**Bodie Hills RV Park  
Revised Specific Plan &  
Final Environmental Impact Report (FEIR)**

**Volume II:  
Technical Appendices**

**Bodie Hills RV Park  
Revised Specific Plan and Final EIR**

**SCH# 97012031**

Figure 1. Sensitive plant locations and survey area for Bodie Hills RV Park, eastern portion.

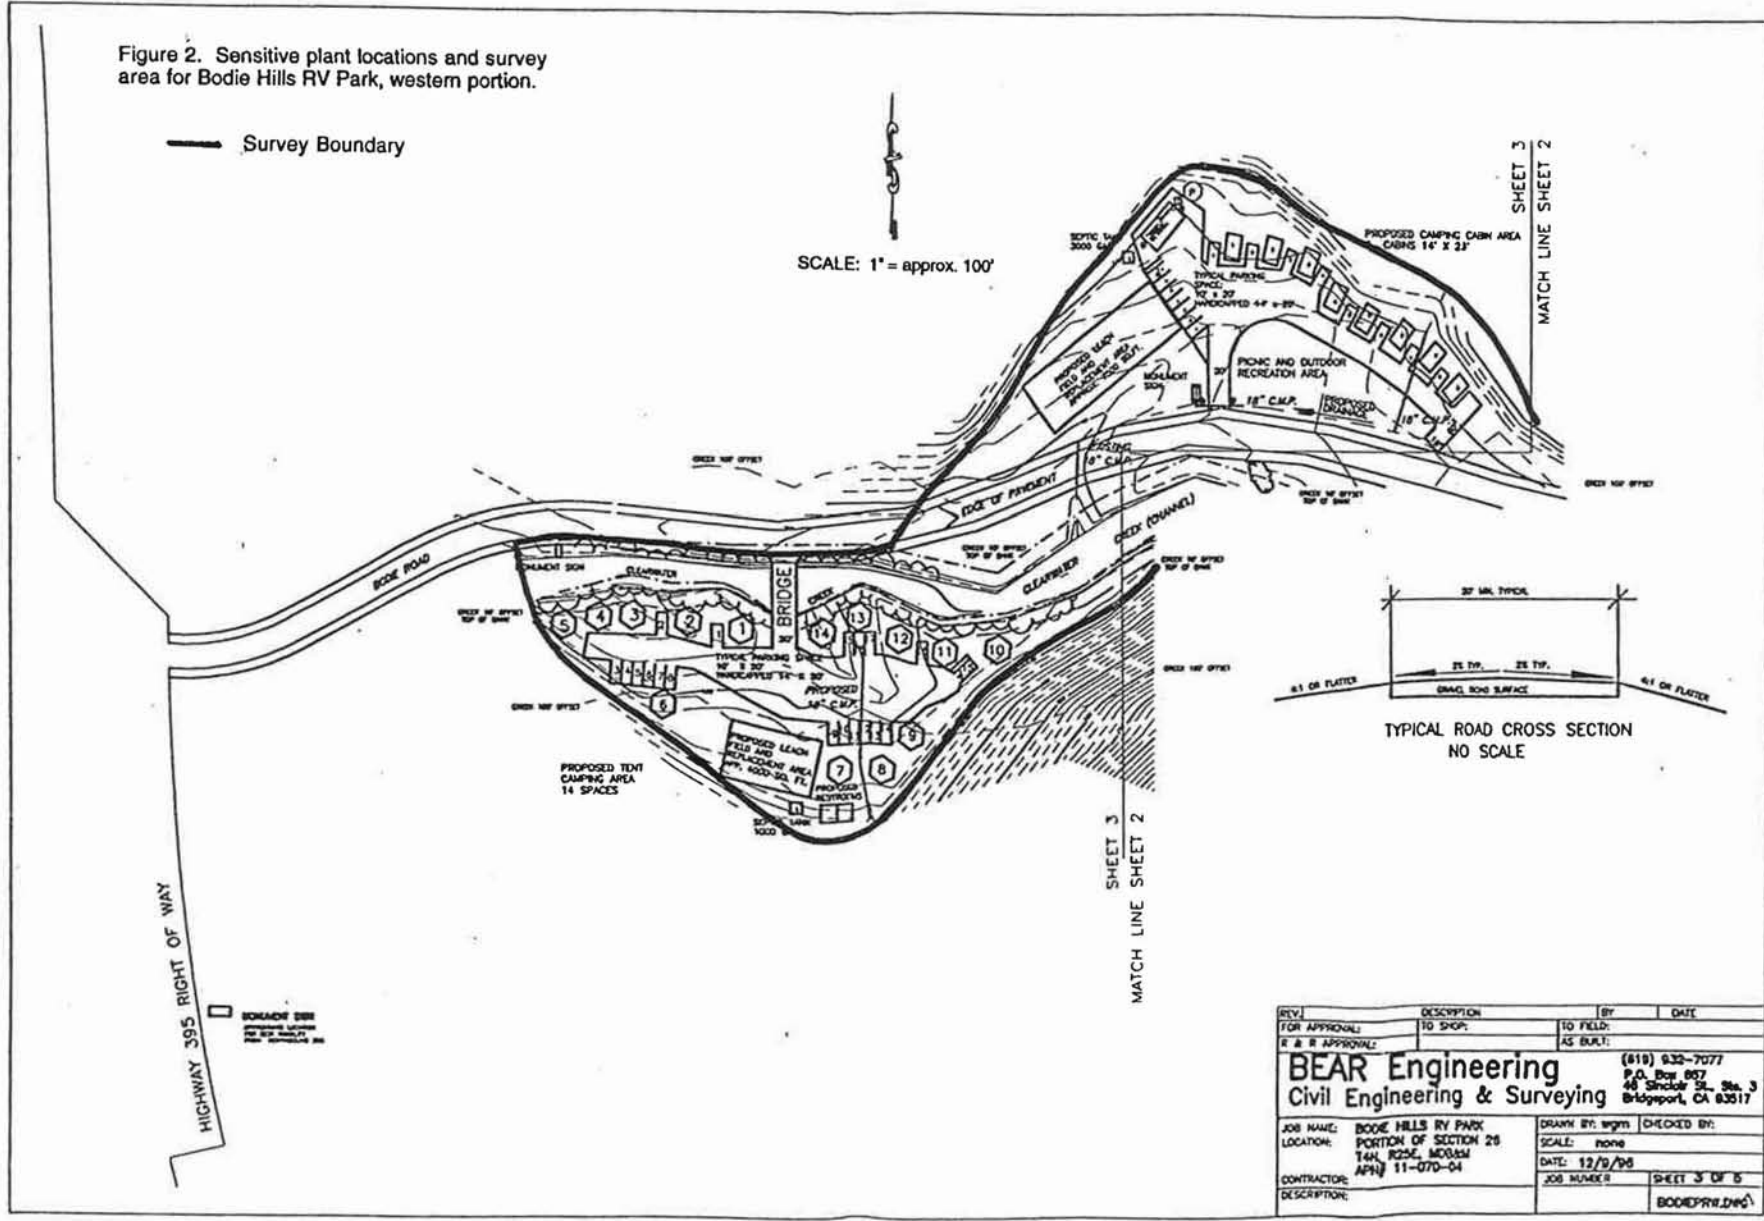
Based on the project map provided (Figures 1 and 2), three 20-foot wide bridges and a foot bridge are proposed to be constructed across the stream channel. Construction of these bridges has the potential to have significant adverse impacts to the stream and the riparian scrub wetland in the stream channel. Other project components would not have potential adverse impacts on the wetland vegetation in the stream channel. The project description and maps provided to us do not provide a description of how the bridges would be constructed, so their potential impacts cannot be fully assessed at this time. Mr. Stephen Higa, of the Mono County Planning Department, has told us that the footings for the bridges are proposed to be located outside of the stream channel and that construction activities would not occur in the channel, except for the need to drive equipment across the stream.

Actual construction plans for the bridges should be provided to insure that the stream channel is avoided. The most recent project maps (Figures 1 and 2) show three of the four bridges with one end just at the top edge of the stream bank. Construction of bridge supports too close to the bank could cause erosion of the banks and adverse impacts to the stream and riparian vegetation. This could be avoided by providing construction specifications that avoid causing bank erosion.

The proposed maintenance building in the southeast portion of the project area is shown overlapping the top of the stream bank (Figure 1). This would appear to require filling in a portion of the stream channel which would have significant adverse impacts to the wetlands. This impact could be avoided by relocating this building away from the bank far enough that it would not require any construction in the channel and not have the potential to cause erosion of the bank.

Two plants of Masonic rock cress occurred at the base of the north-facing canyon wall, on the south edge of the survey area approximately 15 feet west of proposed RV space number 9 (Figure 1). The project map does not show the extent of the slopes that would need to be cut back on the south and west portions of the RV space, but there is a 6-foot vertical cut needed which would normally require the slope to extend back 12 feet from the edge of the space (at a 1:2 slope). This could potentially affect the Masonic rock cress. This impact could be avoided by keeping the disturbance from construction of RV space 9 away from the rock cress. A 10 foot buffer zone from the plants to the top of the cut slope is recommended in order to avoid impacts. Prior to construction, the Masonic rock cress should be located and a buffer zone flagged off.
